**NSLPP MEETING HELD ON 05/02/2025****Attachments:**

**ADDRESS/WARD:** 16 Illiliwa Street, Cremorne**APPLICATION No:** DA75/24**PROPOSAL:** Demolition of an existing dual occupancy and construction of a new dual occupancy.**PLANS REF:**

**OWNER:** Mengyuan Fan**APPLICANT:** ABC Planning Pty Ltd**AUTHOR:** Robin Tse, Senior Assessment Officer**DATE OF REPORT:** 22 January 2025**DATE LODGED:** 5 April 2024**AMENDED:** 8 October 2024**RECOMMENDATION:** Approval (Deferred Commencement)

Figure 12: Proposed maximum building height and LEP building height

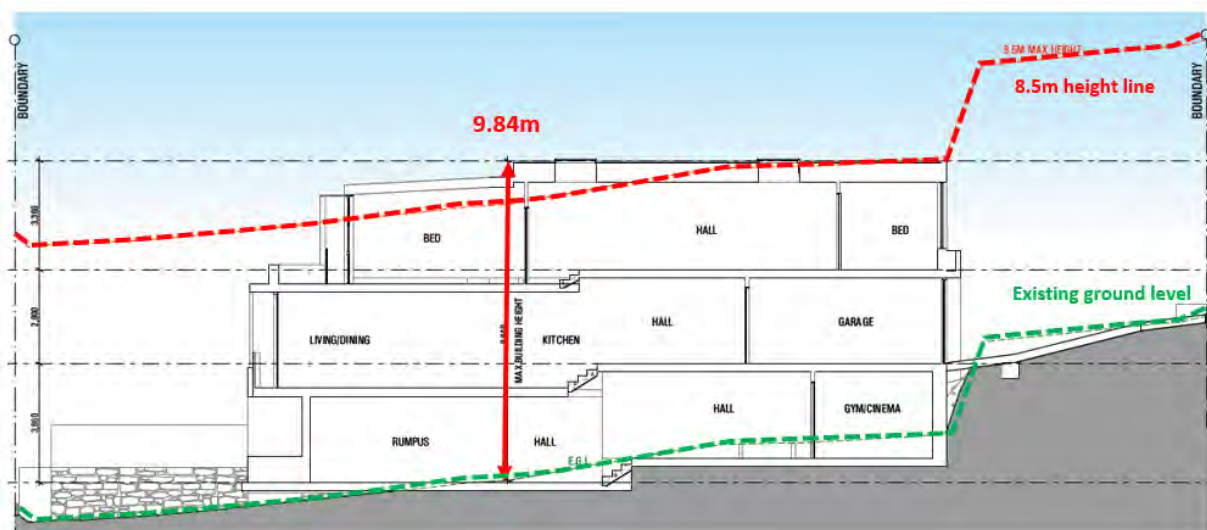
The upper section of the first floor at the rear of the new development would have a maximum building height of 9.84m that fails to comply with the permissible height limit of 8.5m in accordance with clause 4.3 in NSLEP 2013 (Figure 12).

**Figures 13 - 19: Sun-eye Diagrams (Mid Winter)**

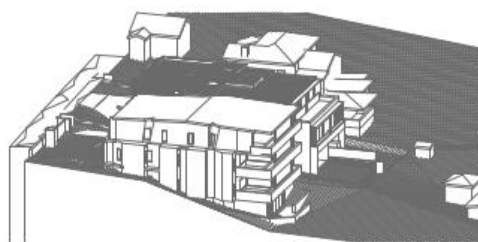
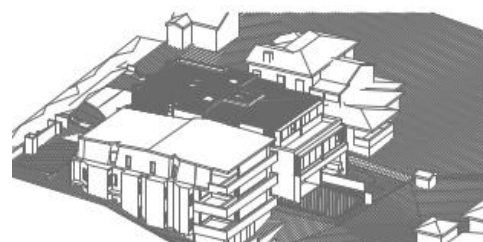
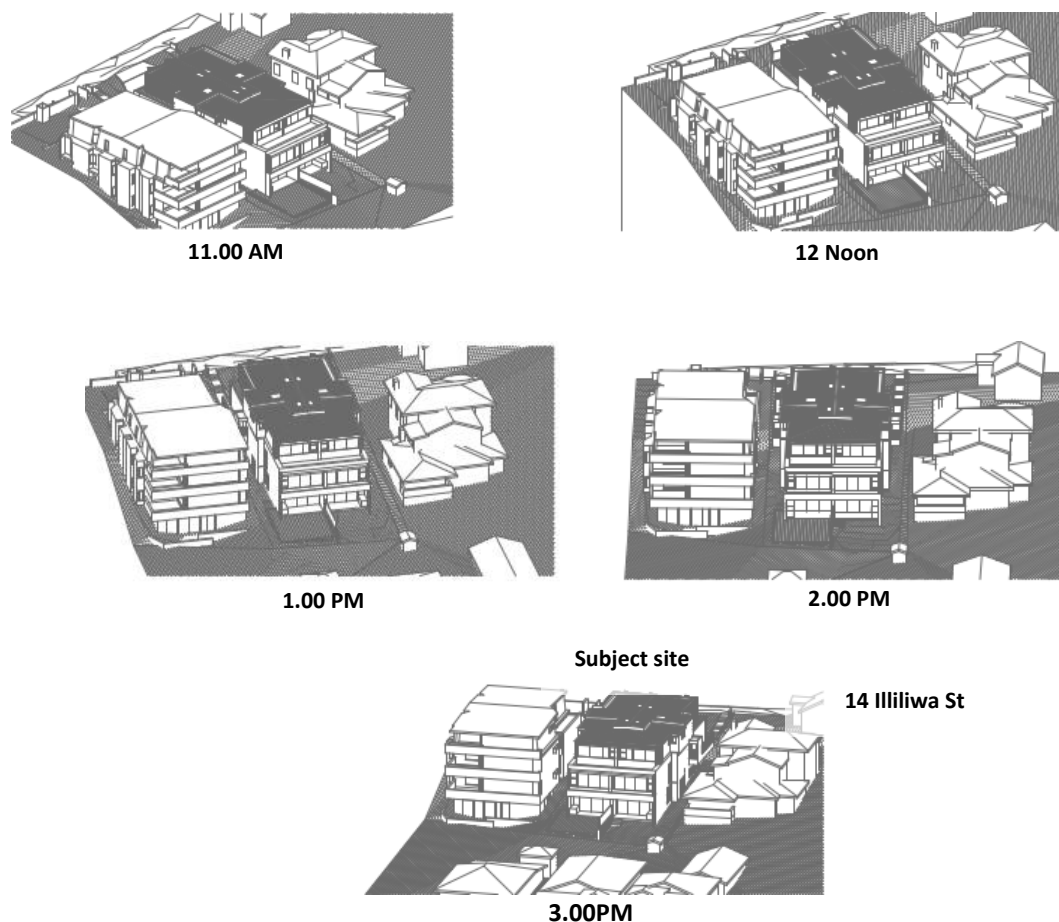
An examination of the submitted sun eye diagrams between 9am and 3pm during mid winter has revealed the proposed development would have no impact on solar access to the windows/balconies on the rear (northern) elevation of No. 14 Illiliwa Street during mid winter.

Furthermore., the first floor windows on the eastern (side) elevation of No.14 Illilwa Street would receive the required 3 hours of sunlight between 9am and 3pm during mid winter.

There would be a reduction in solar access to the ground floor kitchen window on the eastern (side) elevation of No. 14 Illiliwa Street to about 1 hour during mid winter, it is however noted that the shadow would primarily be caused by building elements that comply with building height and building setback requirements. In addition, the north facing openings of a covered deck off the kitchen area would receive more than three (3) hours of sunlight during mid winter.
